**ADDENDUM 6**

PROJECT:  
**NEW NAPANEE WPCP**

2
PENTHOUSE LOUVRE DETAIL  
SKM3
N.T.S.

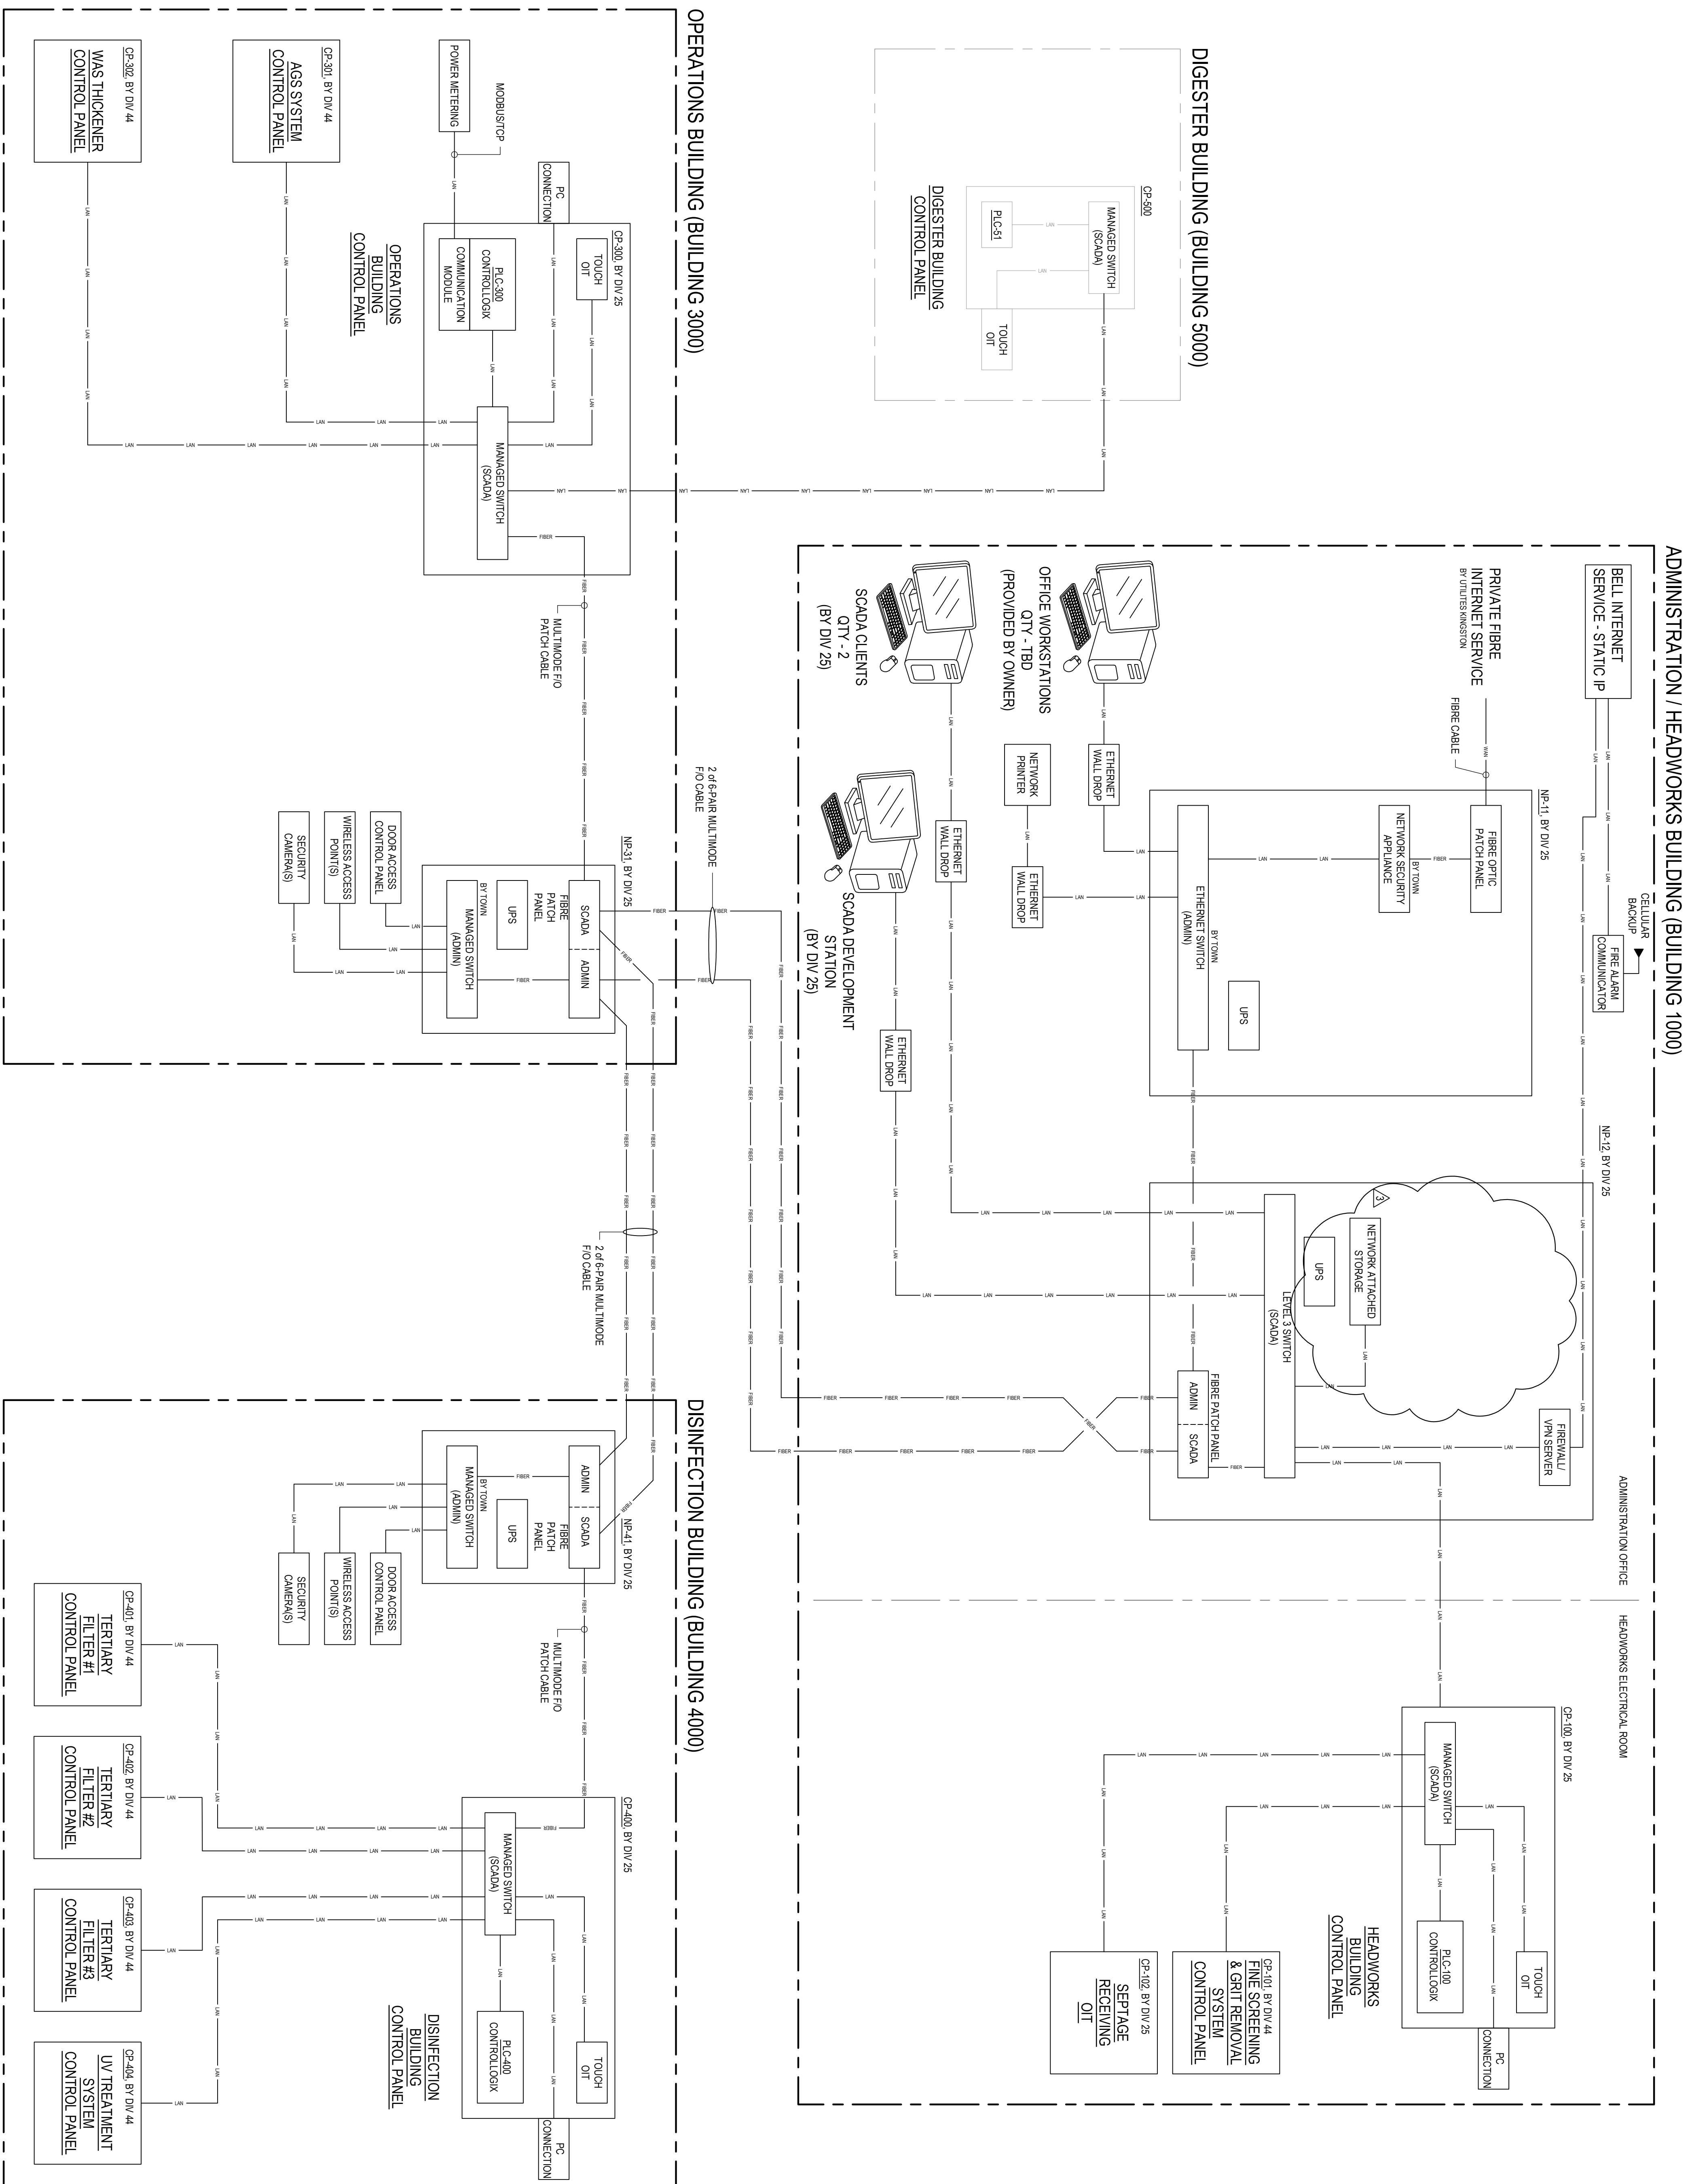
- .2 Provide insulated boiler breeching from boiler up to roof above. Breeching to be insulated. Coordinate with boiler manufacturer. Acceptable material: Duravent or approved equal. Refer to sketch ADD-M3- SKM2.
- .3 Revise penthouse louvre curb height to 900mm. Refer to sketch ADD-M03-SKM3.
